**CORE OPERATING LIMITS REPORT - CYCLE 10, REVISION 2
HOPE CREEK GENERATING STATION
FACILITY OPERATING LICENSE NPF-57
DOCKET NO. 50-354**

In accordance with section 6.9.1.9 of the Hope Creek Technical Specifications, PSEG Nuclear LLC submits Revision 2 of the Core Operating Limits Report (COLR) for Hope Creek Cycle 10 (Report NFS-0181) as Attachment 1 to this letter.

Hope Creek Generating Station
Core Operating Limits Report
Cycle 10/ Reload 9
Effective Date: September 22, 2000

Figure 2.1-8: APLHGR Limit for Fuel Bundle HD08

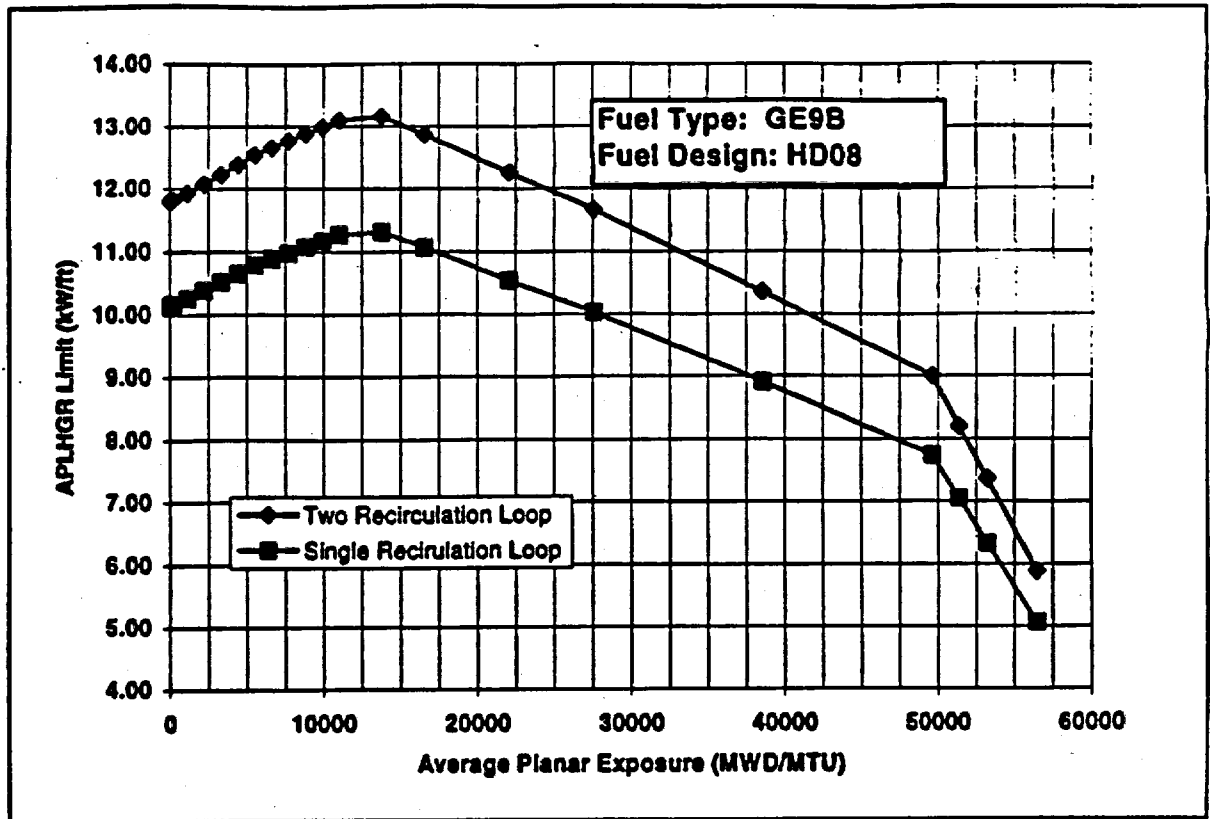
Revision 2 of the COLR corrects typographical errors and relocates the lattice dependent average planar linear heat generation rates (APLHGRs) for GE9B fuel into the body of the report. In addition, errors in planar exposure for fuel bundle HD08 were corrected in Tables 2.1-7 and 2.1-8 and the associated APLHGR limits were recalculated. The changes have no effect on core operating limits in Cycle 10 to date.
